# PLANNING

Project 38 Chester Terrace NW1 4ND

Drawing Title: Proposed Rear (East) Street Elevation

Drawing No. P2103 Rev. C

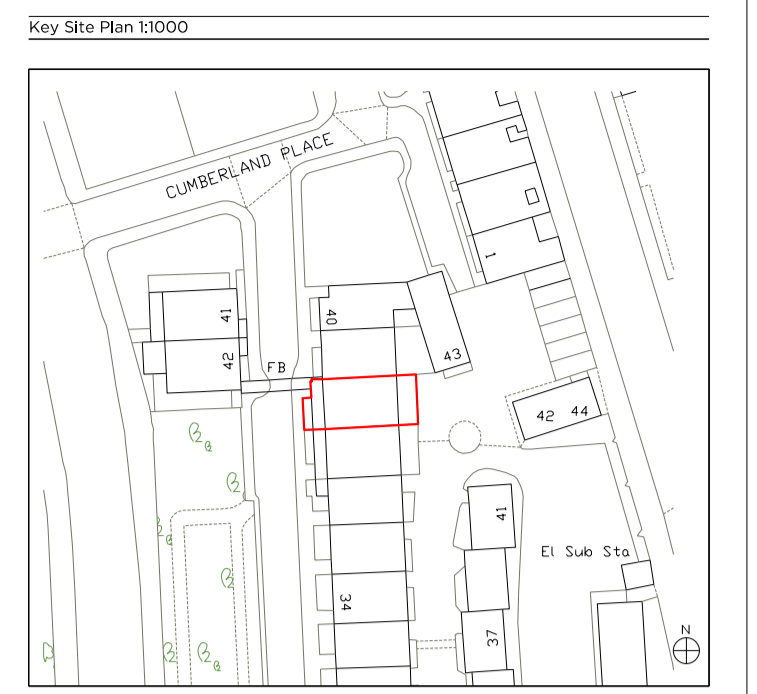
Revision Notes	
Rev. A	29.03.2021
A.1	Privacy screen hatch amended to match existing screening at No.39 Chester Terrace.
Rev. B	06.04.2021
B.1	Existing opening width adjusted to accommodate a new gate.
Rev. C	03.03.2022
C.1	Gate within screening to be relocated to work with stair relocation
